TITLE: SUSPECTED AREAS (1 EACH +Y AND -Y) OF LOW FOAM ON THE
ET/SRB FITTING

PR ET-093-TS-0009

SUSPECTED AREAS OF LOW FOAM ON ET/SRB FITTING CLOSEOUT

National Aeronautics and Space Administration John F. Kennedy Space Center				1. Report Number <input type="checkbox"/> INTERIM PROBLEM REPORT <input checked="" type="checkbox"/> PROBLEM REPORT <input type="checkbox"/> DISCREPANCY REPORT		PV-6-389 224		PAGE 1 OF 20

Figure 10-1: Defect Maps

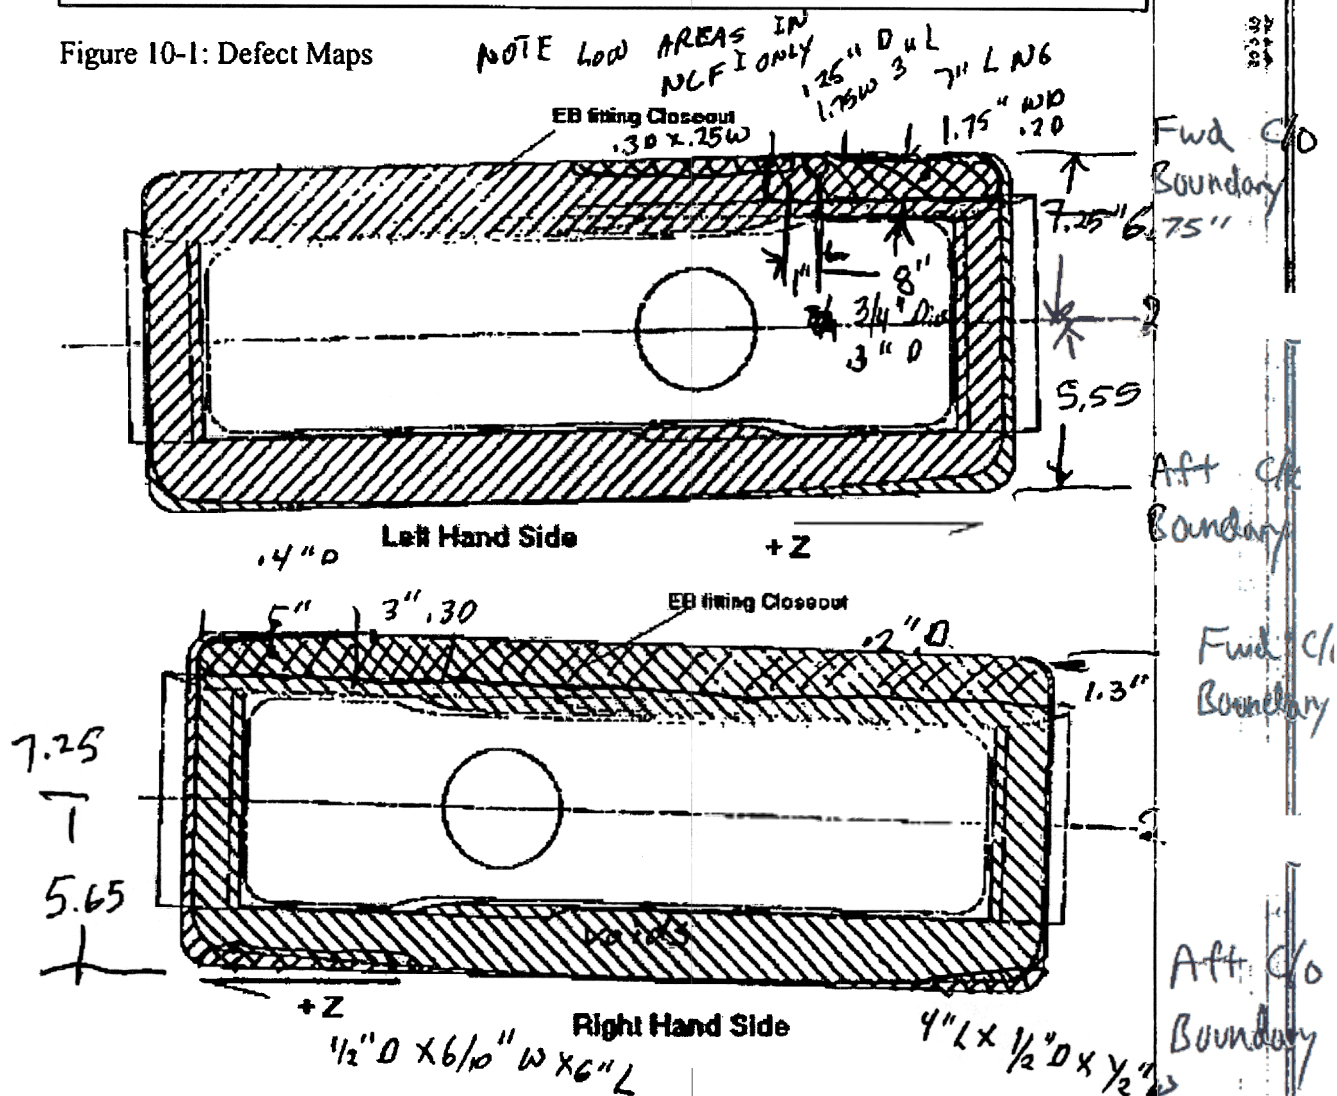
Map areas which do not meet drawing allowances of flush +0/-10 on figure 10-1. Record Length (Z direction), Width (X direction) and Depth (from the isolator) on Figure 10-1

Measure the distance from the center of the EB fitting (XT 2058) to the top and the bottom of the EB fitting cut out. Record on Figure 10-1 Maps.

① Measure fwd and aft extent of EB fitting closeout boundary.

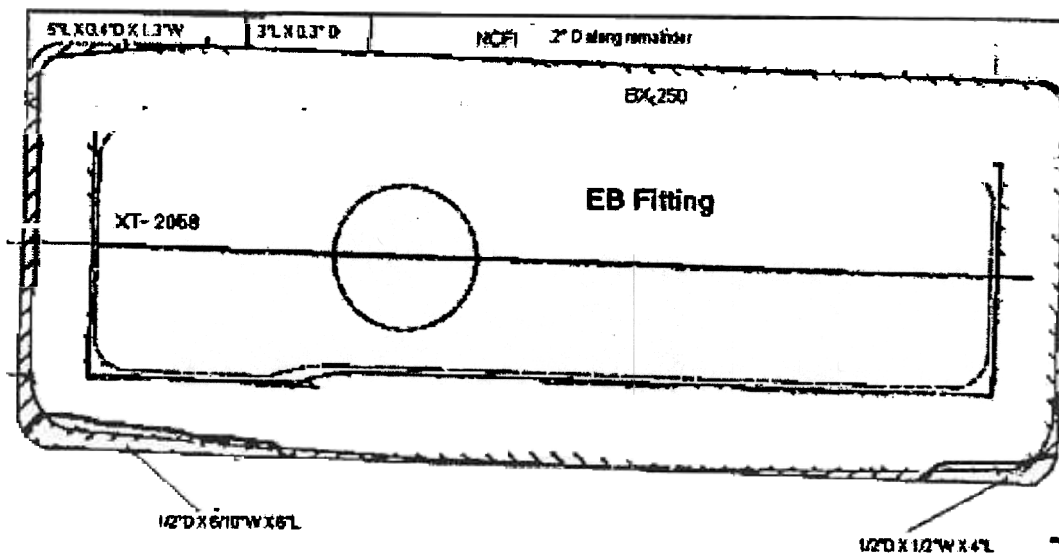
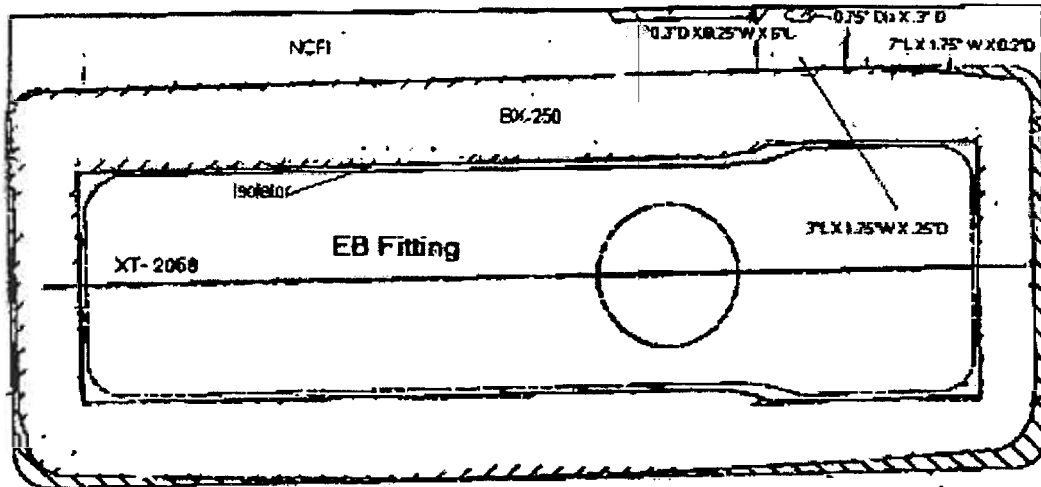
None of the defects meet 80901019010 in-process rework allowances for areas adjacent to a scheduled close-out in that they are greater than 4 inches long and are greater than 25% of the close-out boundary. It should be noted that the defects extend to their deepest at the +Z ends (.3 in below min dwg for +Y side and .2 in below in dwg for -Y side). The ends of the cut out (+Z and -Z) are where the NCFI is the thickest.

MR action is requested to accept the close-out of the PD 1.0 NCFI over trims for use as is. Acceptance of this condition is based on the following rationale:

Sufficient NCFI remains to maintain temps within structural limits

Low areas are within the envelope of the fairing/closeout

Close-out application performed per the following details (OMI T1297.002) shall encapsulate the PD 1.0 low areas providing additional thermal protection.

- Construct molds per standard procedures (reference OMI T1297.002)
- Vent molds at the center.
- Inject 50cc of foam at the -Z end and at the +Z end.
- Allow excess foam to vent out the center.
